Received by OCD: 2/22/2027 1:14:52			Form C-Rag 1 of 7	
<u>District I</u> – (575) 393-6161	Energy, Minerals and Natu	ral Resources	Revised July 18, 2013	
1625 N. French Dr., Hobbs, NM 88240 <u>District II</u> – (575) 748-1283	OVI GOVIGEDAVI TOO		WELL API NO. 30-25-28905	
811 S. First St., Artesia, NM 88210 <u>District III</u> – (505) 334-6178	OIL CONSERVATION DIVISION		5. Indicate Type of Lease	
1000 Rio Brazos Rd., Aztec, NM 87410	1220 South St. Francis Dr.		STATE STATE	
<u>District IV</u> – (505) 476-3460 1220 S. St. Francis Dr., Santa Fe, NM	Santa Fe, NM 87	/505	6. State Oil & Gas Lease No.	
87505			96101	
SUNDRY NOTI	ICES AND REPORTS ON WELLS		7. Lease Name or Unit Agreement Name	
DIFFERENT RESERVOIR. USE "APPLIC	SALS TO DRILL OR TO DEEPEN OR PLU CATION FOR PERMIT" (FORM C-101) FO	OR SUCH	T. 11 A 43 CG	
PROPOSALS.)			Kochia AAM State	
	Gas Well  Other SWD		8. Well Number 1 SWD

2. Name of Operator SUNDOWN ENERGY LP			9. OGRID Number	
3. Address of Operator			232611 10. Pool name or Wildcat	
16400 DALLAS PARKWAY, STE	E. 100 DALLAS, TX 75248		Devonian

## CONDITIONS OF APPROVAL FOR PLUGGING AND ABANDONMENT OCD - Southern District

## WELL DATA SHEET PROPOSED

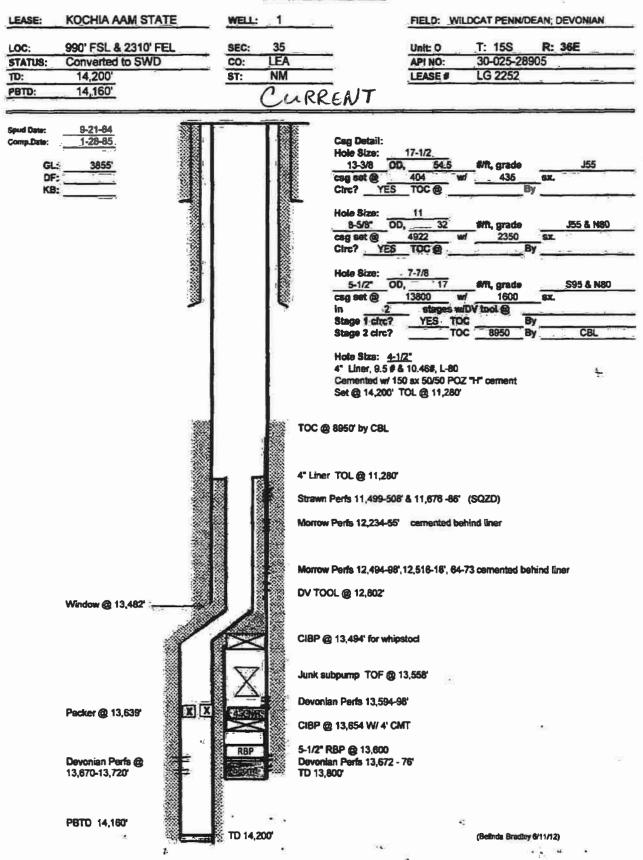
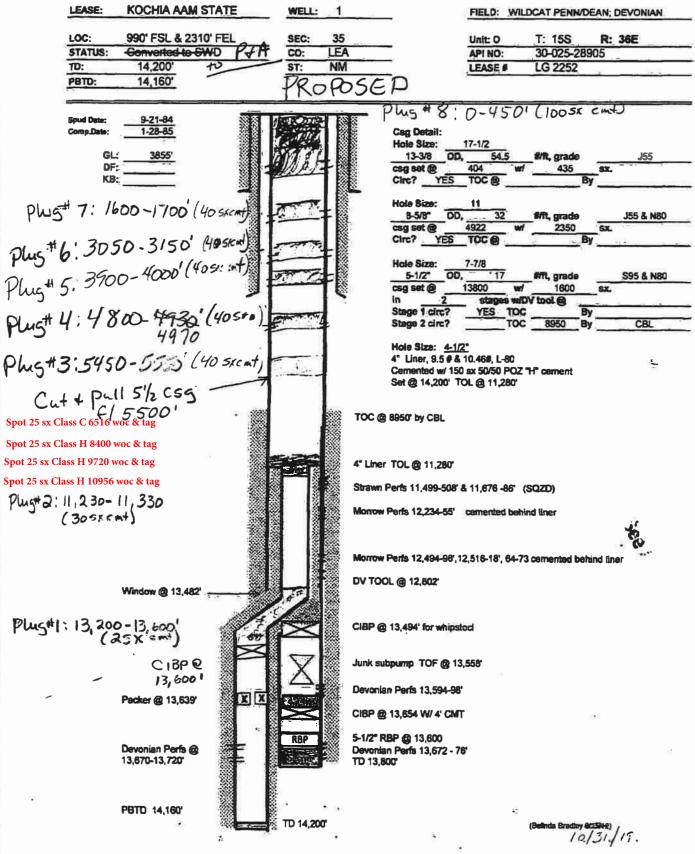
13. Describe proposed or compl	leted operations. (Clearly state all p	ertinent details, an	d give pertinent dates, including estimated date	
of starting any proposed wo	ork). SEE RULE 19.15.7.14 NMAC	C. For Multiple Con	mpletions: Attach wellbore diagram of	
proposed completion or reco	ompletion.		4(b) Spot 25 sx Class H 10956 woc & tag

1) Set CIBP @ 13,600'.			4 (c) Spot 25 Sx Class H 9720 woc & tag	
	oot 25 sxs balanced cement plug 13,	.200' to 13.600'. w	4 (d) Spot 25 sx Class H 8400 woc & ta oc&tag 4 (e) Spot 25 sx Class C 6516 woc & ta	
	isplace hole w/ 9.5 PPG mud. Press	•	4 (e) opot 20 3x 01a33 0 0010 woc a ta

OCD Reviewer	Condition
kfortner	See attached conditions of approval Note Changes to procedure
